**NSLPP MEETING HELD ON 07/12/2022****Attachments:**

**ADDRESS/WARD:** 45-51 Ridge Street, North Sydney**APPLICATION No:** DA 241/22**PROPOSAL:** Fit out and use of an existing building as a Centre Based Child Care Facility and Educational Facility (Kindergarten), playgroup location and out of school hours care facility.**PLANS REF:**

**OWNER:** North Sydney Council**APPLICANT:** Cameragal Montessori School Pty Ltd**AUTHOR:** John McFadden, Consultant Planner  
State Planning Services**DATE OF REPORT:** 29 November 2022**DATE LODGED:** 12 August 2022**RECOMMENDATION:** Approval

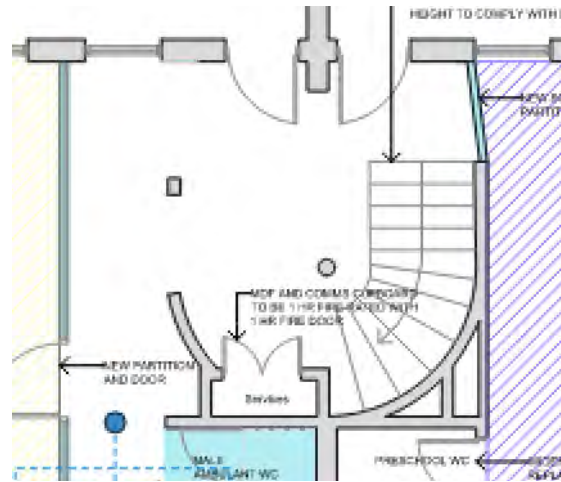
**Ensure that the lift landing call buttons are located at least 500mm from the internal corner formed by the adjacent lobby to corridor separating doorway at both levels.**

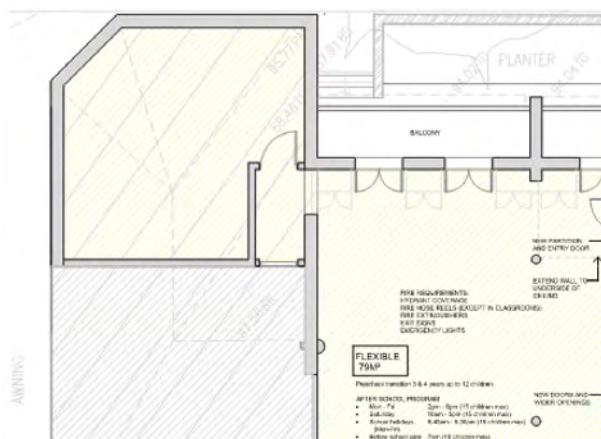
Ensure that the floor landings of the curved stairway provide sufficient area for a 180° accessible turn to serve the corridor in accordance with Clause 6.5.3 of AS 1428.1-2009.
